**Comments of the  
Mono Lake Committee**

**Draft Synthesis**

**of Instream Flow Recommendations**

## RE: Mono Basin draft instream flow recommendations

**Comment D.16** (p.43)

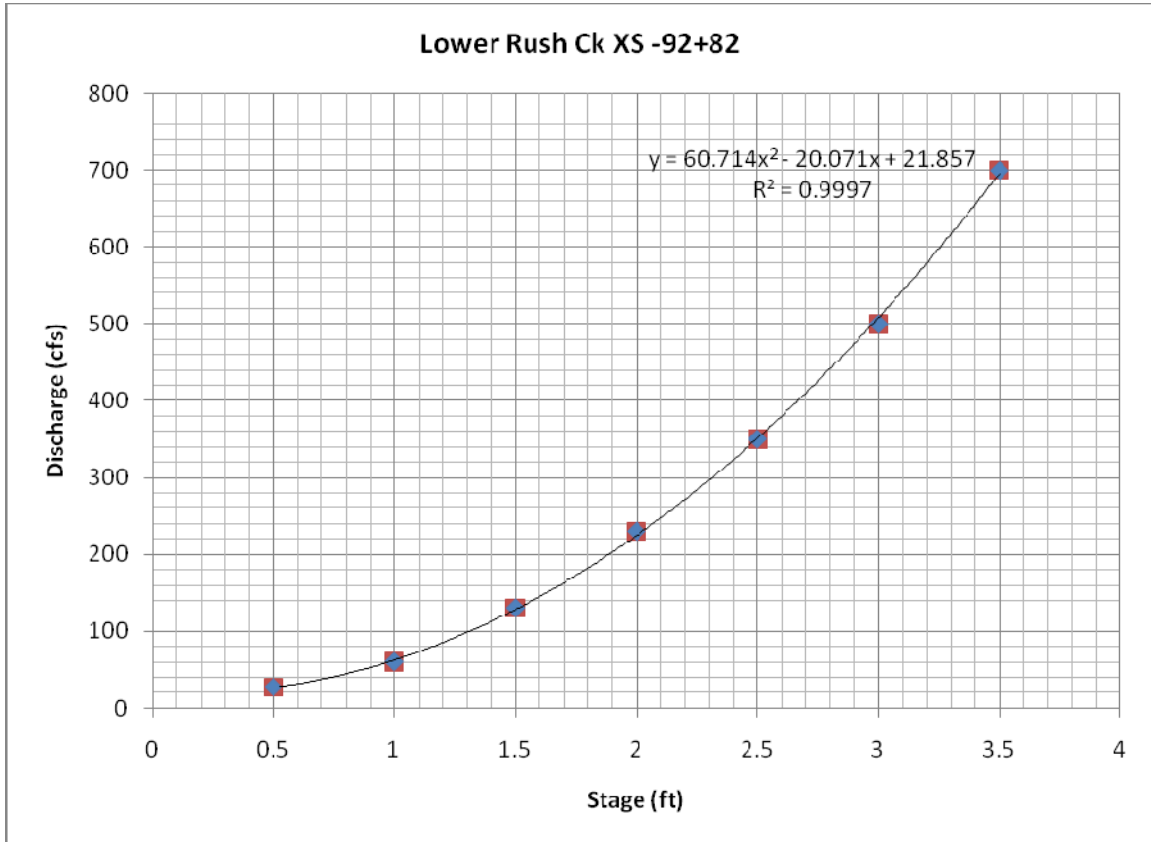
The highest peaks are in early-to-mid July in Fig. 2-7 in order to take advantage of spilling the reservoir and passing the high peak downstream. Another goal is to match up Rush Creek's peak with Parker and Walker creek peaks in order to maximize the magnitude in the bottomlands. Early June and late June are common times for these tributaries to peak, and July in some of the wettest years. Targeting the timing of seeding (p.97) should match up with the recession limb, not the peak—especially on emergent floodplains where seedlings could be washed away. Therefore, if the seeding is, for example, July 6 to August 17, then the peak should be prior to July 6 with the descending limb beginning on July 6. For emergent floodplains, this period would extend until flows drop below the 120 cfs threshold. The report seems to erroneously call for a peak during those dates, counting days above the threshold on the ascending limb as good days, which may be true for higher areas away from the channel, but would not be true for emergent floodplains.

**Comment D.19** (p.43)

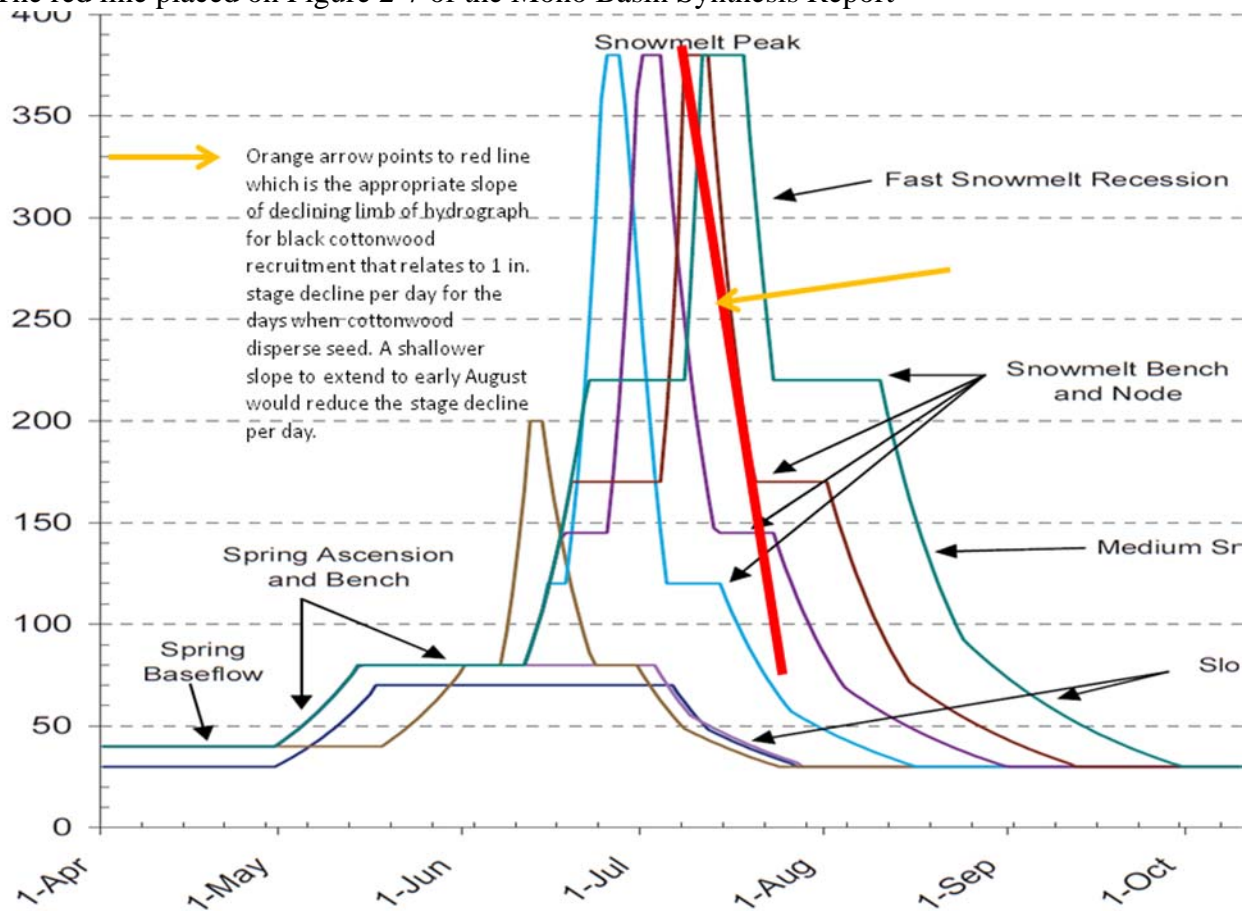
The red line placed on Figure 2-7 of the Mono Basin Synthesis Report

represents the appropriate discharge decline for the period July 6 to early August (ca. 35 days +/- which apparently is the cottonwood seed dispersal period) at 2.5 cm (1 inch) stage decline per day, this is equal to 21 cfs decline in discharge calculated from the equation developed in the first figure above. This line and the decline and dates is based on the "recruitment box" model concept developed by Mahoney and Rood (1998). The report should re-evaluate the recommended stage decline per day based on this information.
